Addendum: 2

Date: 08/21/2026

Project: Northwest Allen County Schools
Huntertown Elementary School Mechanical Upgrades

Comm #: 26842

1 ENLARGED BOILER ROOM - DEMOLITION PLAN
- UNDER SEPARATE CONTRACT
1/4" = 1'-0"

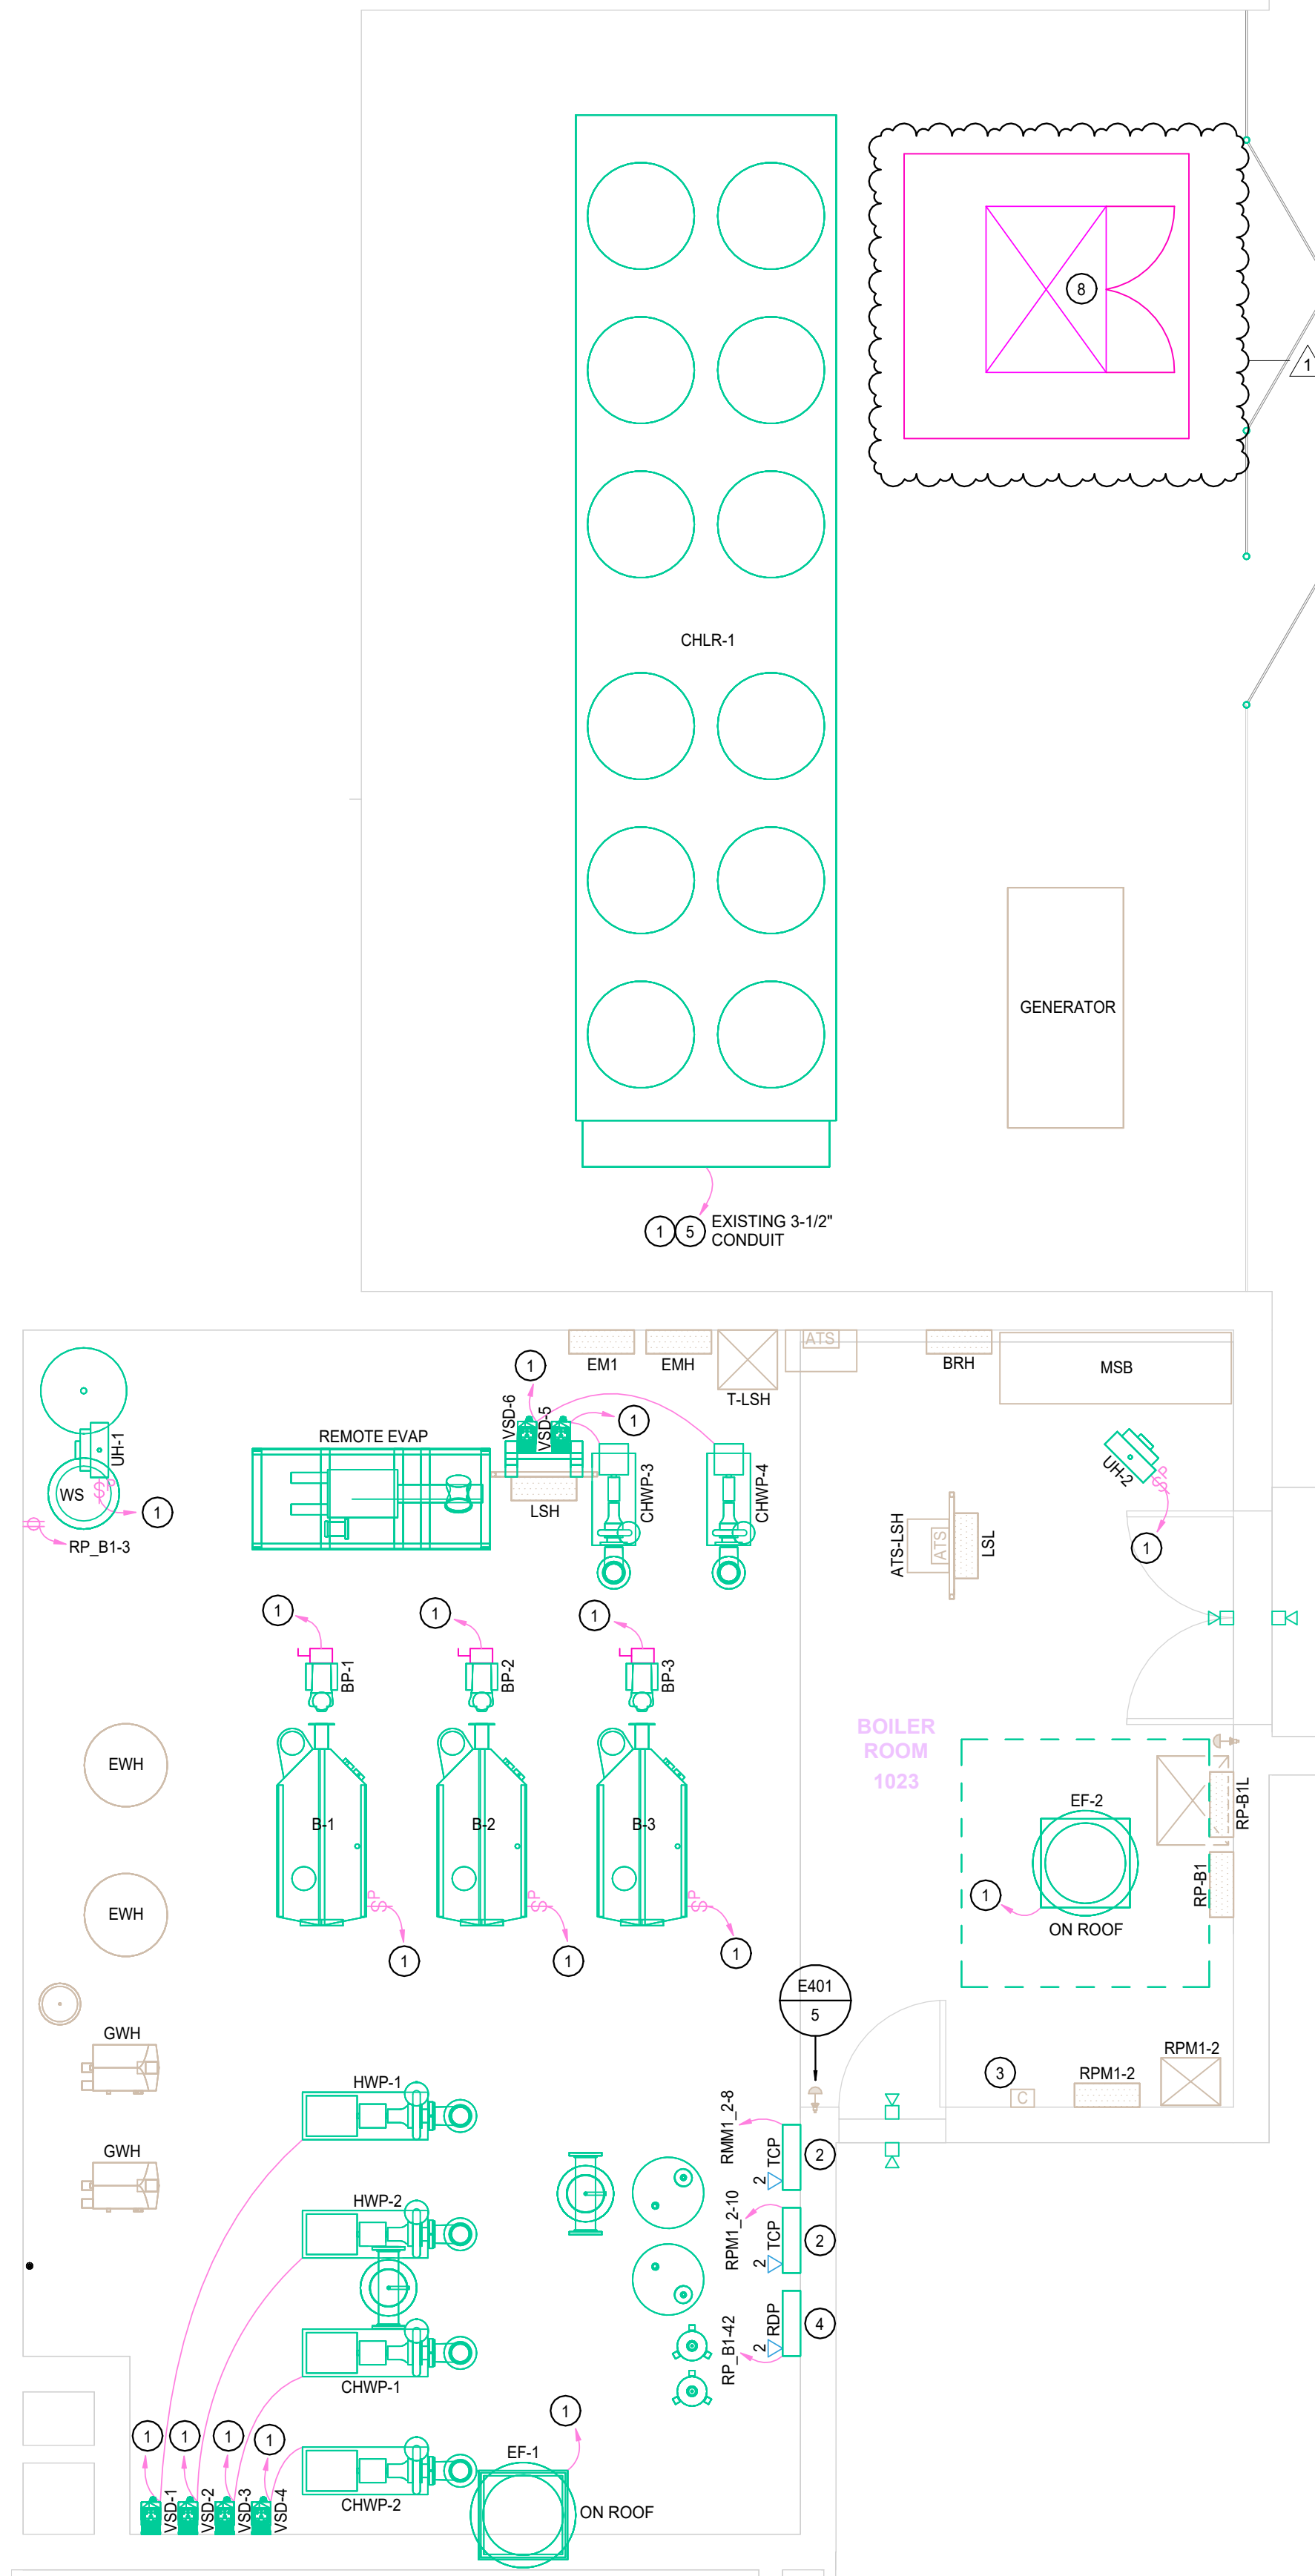
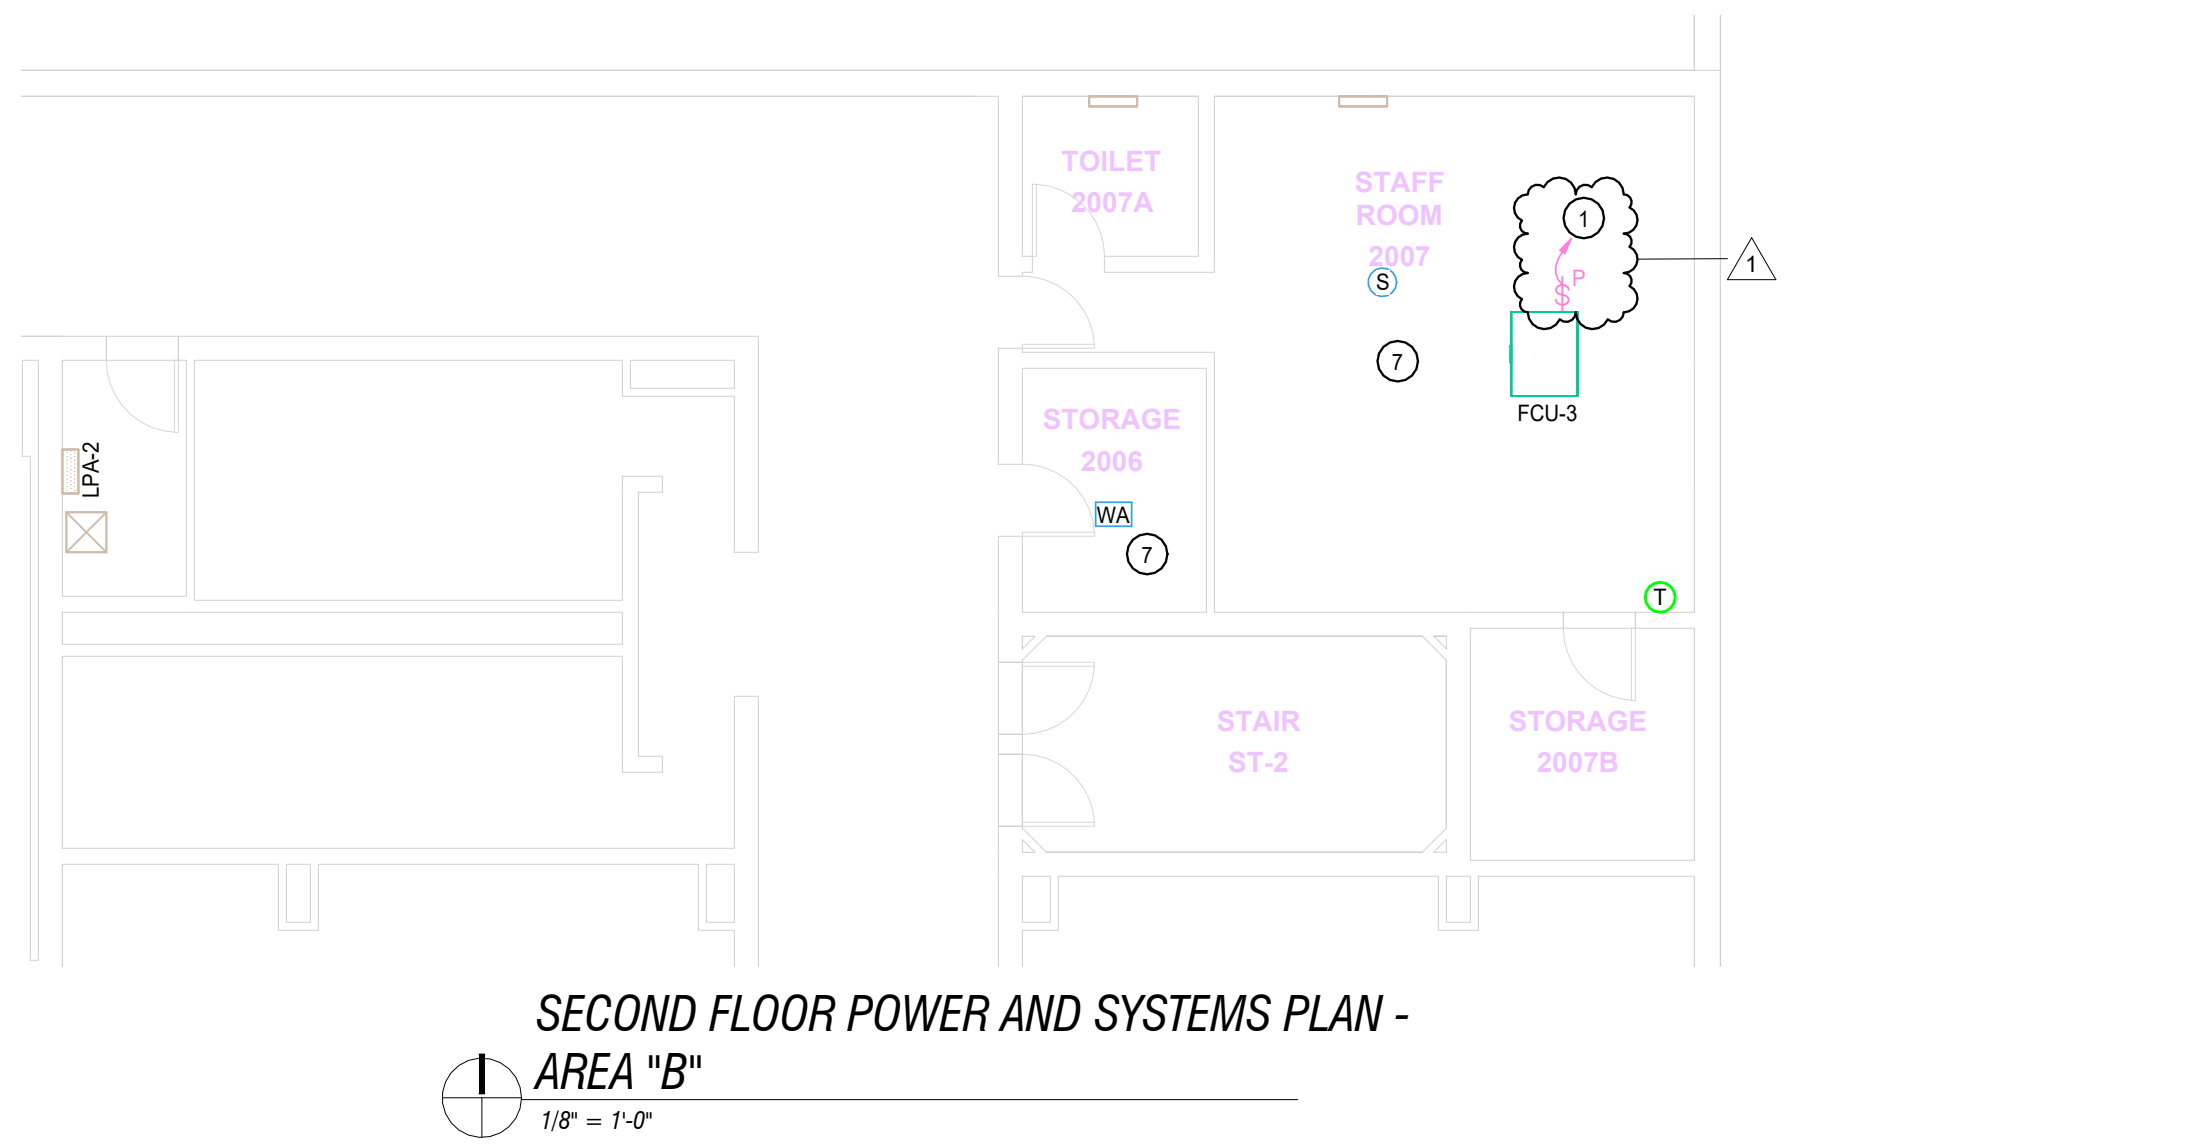
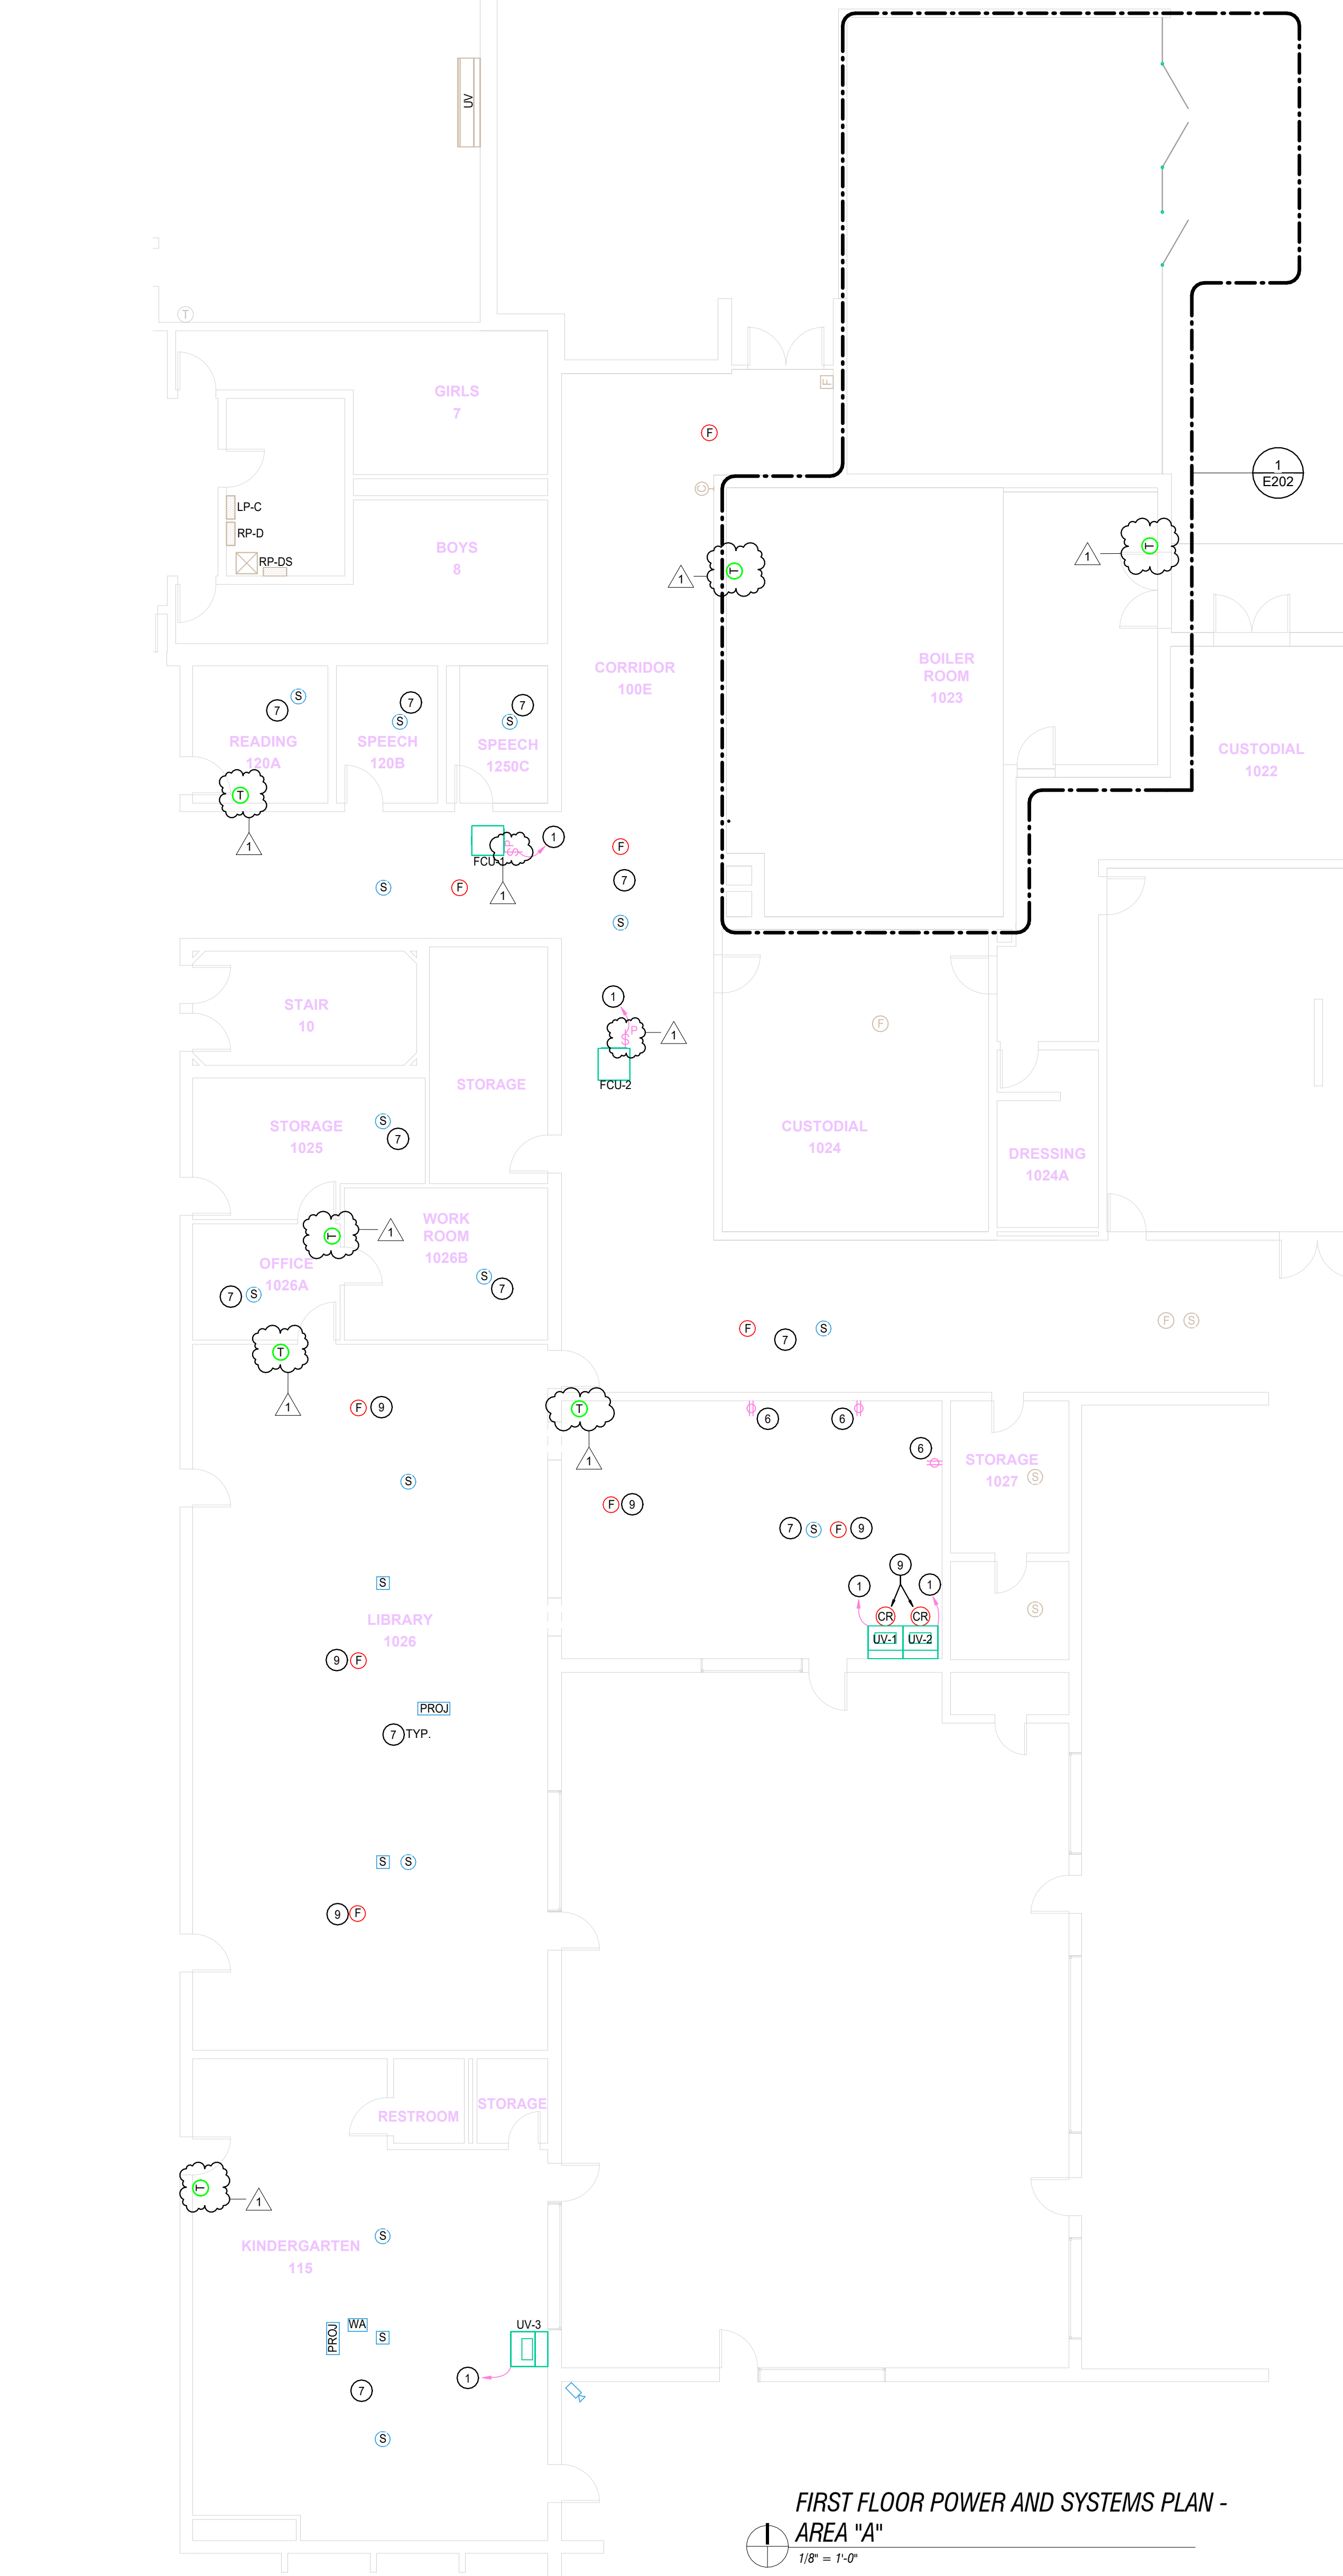
- A. Revised plan note #11 and utility transformer and pad scope. Electrical scope of work associated to be under separate contract. Shown for reference only.

11.		DISCONNECT SECONDARY CONDUCTORS FROM TRANSFORMER. UTILITY TRANSFORMER TO BE REMOVED. PREPARE EXISTING CONDUITS AND CONDUCTORS TO BE PULLED BACK AND RELOCATED TO NEW UTILITY TRANSFORMER LOCATION. REMOVE EXISTING CONCRETE UTILITY PAD AND PREPARE FOR POUR OF NEW UTILITY PAD. COORDINATE WITH UTILITY COMPANY (AEP) AS REQUIRED.

ELECTRICAL SCOPE ASSOCIATED WITH BOILER ROOM, CHILLER AND UTILITY TRANSFORMER TO BE COMPLETED UNDER SEPARATE CONTRACT. REFER TO ENLARGED BOILER ROOM DEMOLITION PLAN FOR ADDITIONAL INFORMATION.
